H. B. ROBINSON STEAM ELECTRIC PLANT UNIT NO. 2

AMENDMENT TO FACILITY OPERATING LICENSE

Amendment No. 39  
License No. DPR-23

ATTACHMENT TO LICENSE AMENDMENT NO. 39

Protection Boundaries  
N-loop Operation

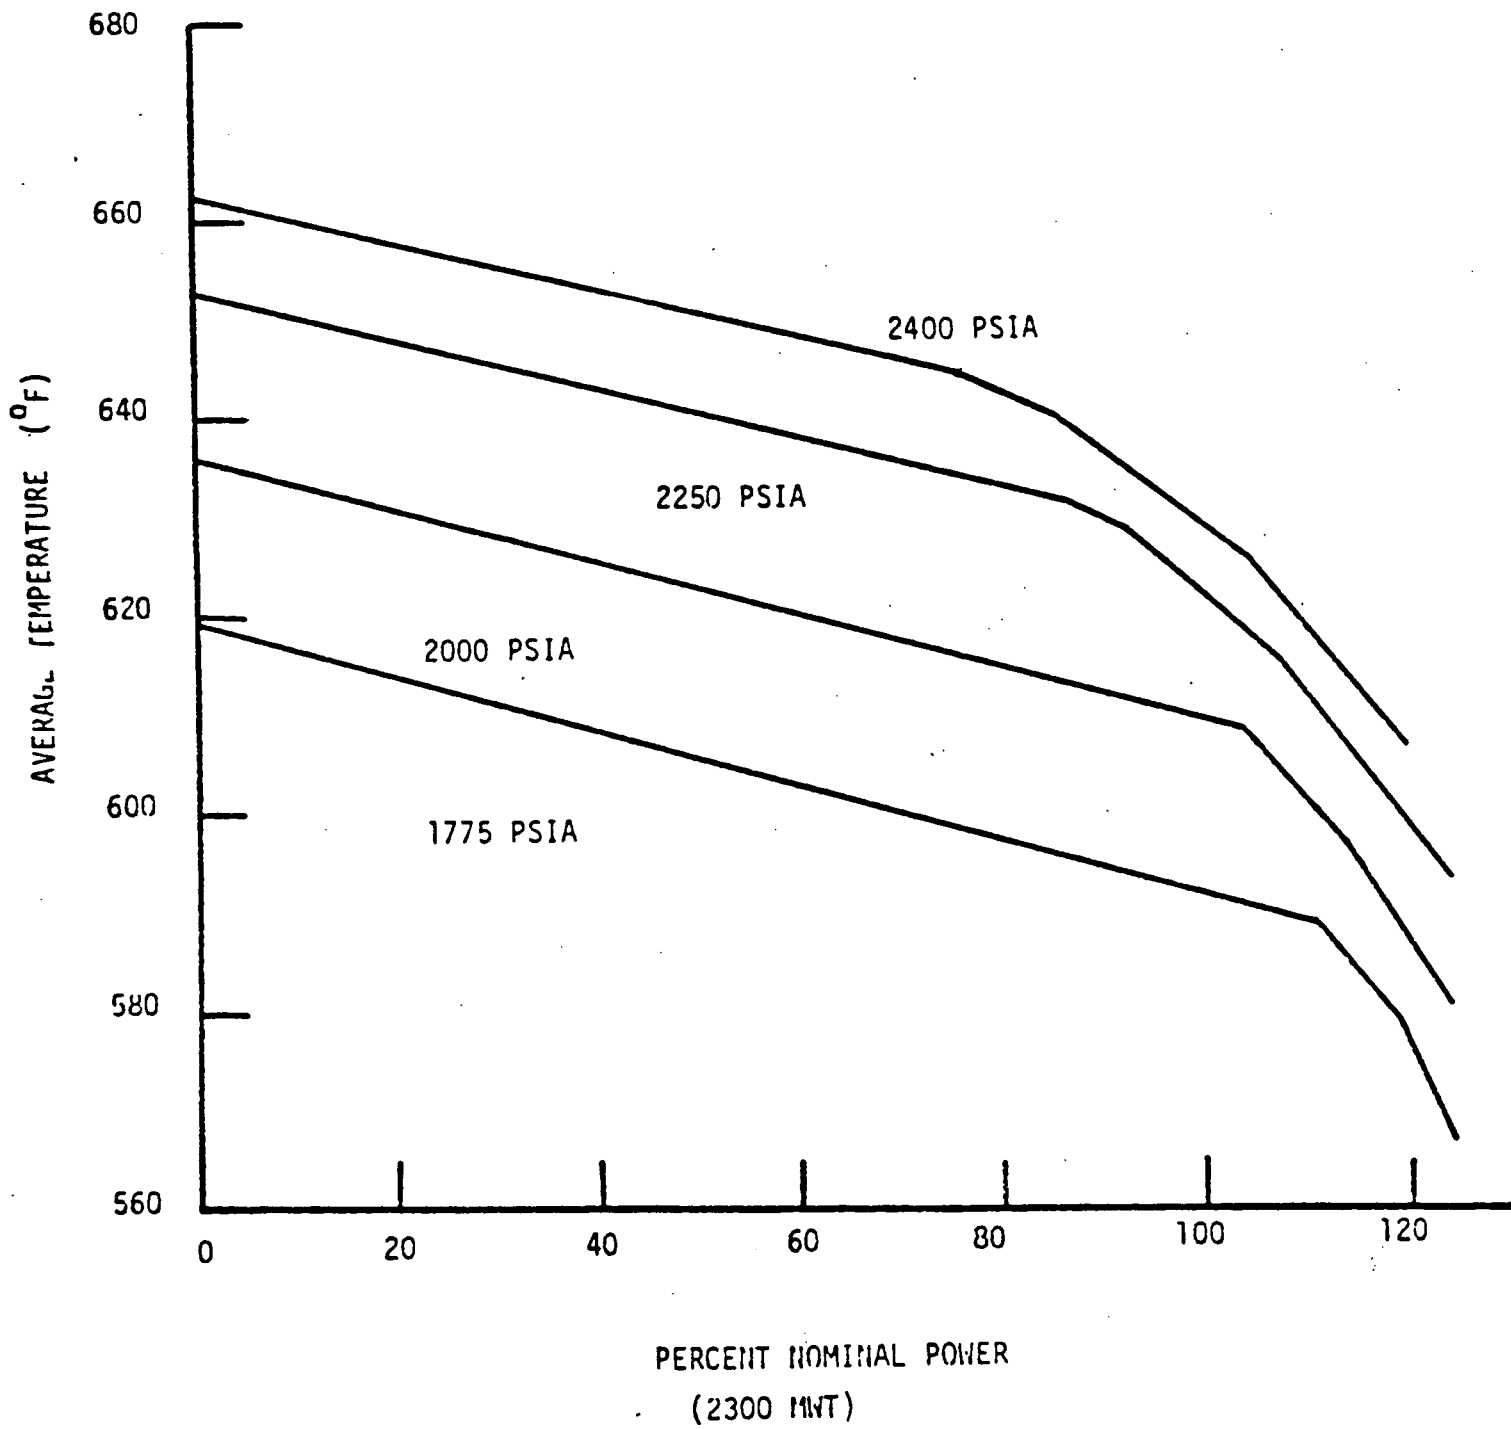
is assured. This latter limit is arbitrary but cannot be reached due to the permissive 8 protection system setpoint which will trip the reactor on high nuclear flux when only two reactor coolant pumps are in service. Additional peaking factors to account for local peaking due to fuel rod axial gaps and reduction in fuel pellet stack length have been included in the calculations of the curves shown in Figures 2.1-1 and 2.1-2. The figures also include the effects of uprating to 2300 MWt. <sup>(4)</sup>

The overpower and overtemperature protection system setpoints have been revised to include effects of fuel densification and the increase in rated thermal output to 2300 MWt on core safety limits. The revised setpoints in the Technical Specifications insure the combination of power, temperature, and pressure will not exceed the core safety limits as shown in Figures 2.1-1 and 2.1-2.

FIGURE 3.1.4-1

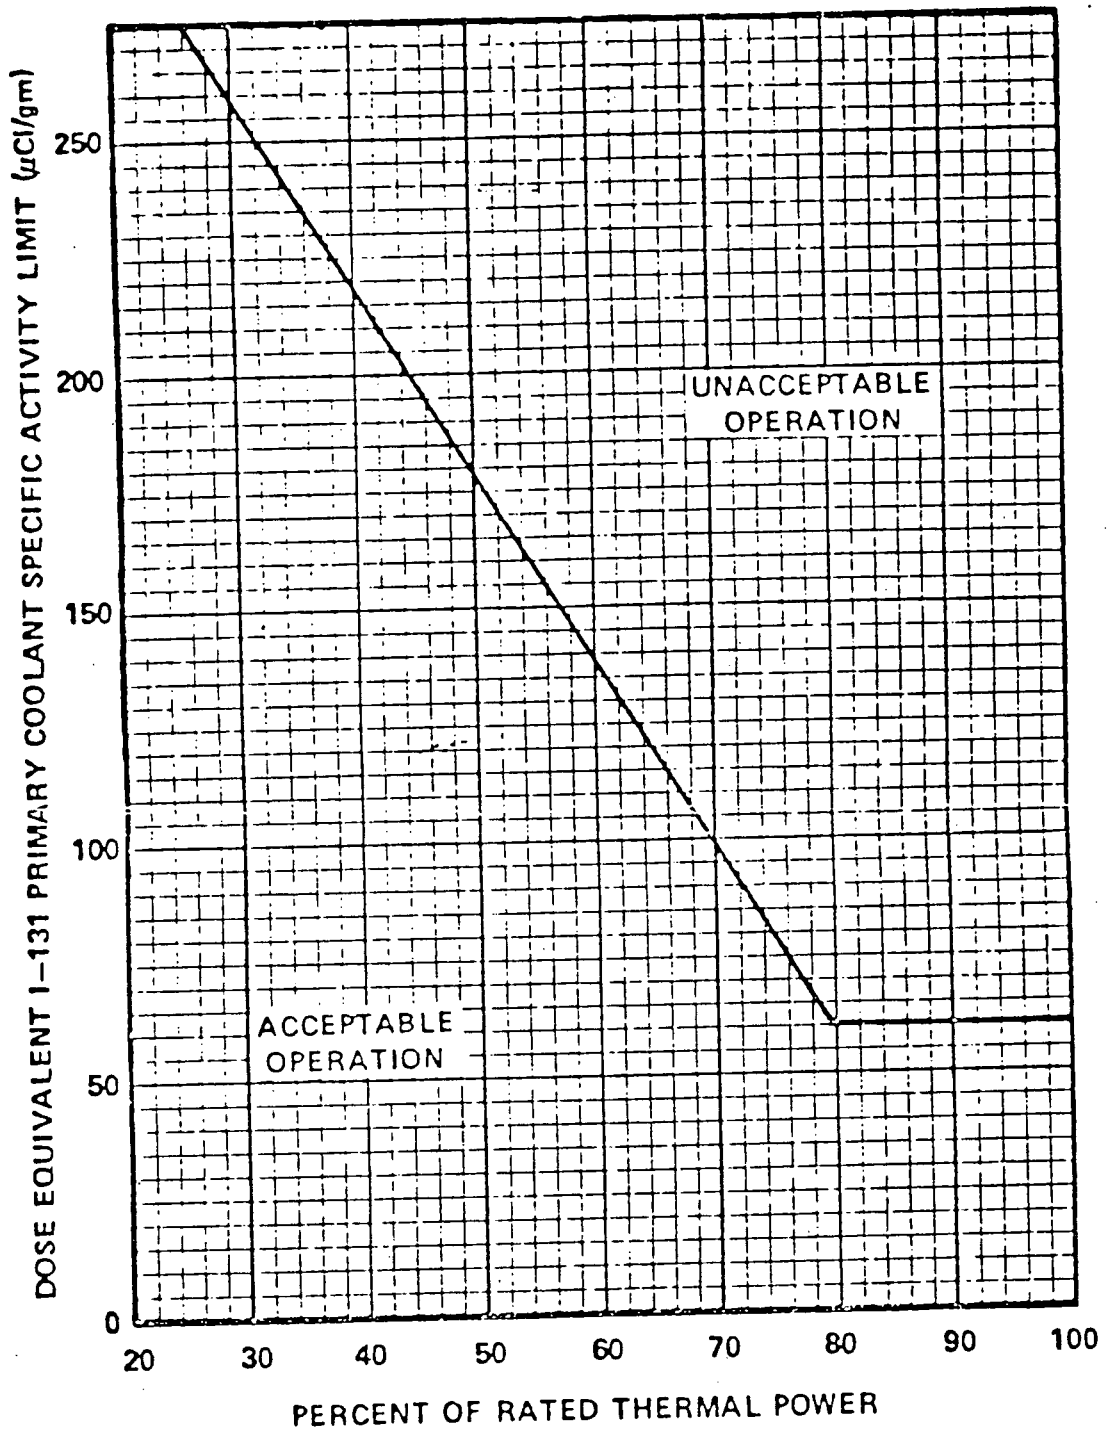
Whenever the reactor is critical or the average reactor coolant temperature is greater than  $500^\circ\text{F}$ , with the specific activity of the primary coolant  $> 1.0 \mu\text{Ci}/\text{gram}$  DOSE EQUIVALENT I-131 but within the allowable limit (below and to the left of the line) shown on Figure 3.1.4-1, operation may continue for up to 48 hours provided that the cumulative operating time under these circumstances does not exceed 800 hours in any consecutive 12 month period. With the total cumulative operating time at a primary coolant specific activity  $> 1.0 \mu\text{Ci}/\text{gram}$  DOSE EQUIVALENT I-131 exceeding 500 hours in any consecutive six month period, prepare and submit a Special Report to the Commission pursuant to Specification 6.9.2 within 30 days indicating the number of hours above this limit.

With the specific activity of the primary coolant  $> 1.0 \mu\text{Ci}/\text{gram}$  DOSE EQUIVALENT I-131 for more than 48 hours during one continuous time interval or exceeding the limit line shown on Figure 3.1.4-1, be in at least HOT SHUTDOWN with  $T_{\text{avg}} < 500^\circ\text{F}$  within 6 hours.

The statement permitting POWER OPERATION to continue for limited time periods with the primary coolant's specific activity  $> 1.0 \mu\text{Ci}/\text{gram}$  DOSE EQUIVALENT I-131, but within the allowable limit shown on Figure 3.1.4-1, accomodates possible iodine spiking phenomenon which may occur following changes in THERMAL POWER. Operation with specific activity levels exceeding  $1.0 \mu\text{Ci}/\text{gram}$  DOSE EQUIVALENT I-131 but within the limits shown on Figure 3.1.4-1 must be restricted to no more than 800 hours in any consecutive 12 month period, since the activity levels allowed by Figure 3.1.4-1 increase the 2 hour thyroid dose at the site boundary by a factor of up to 20 following a postulated steam generator tube rupture.
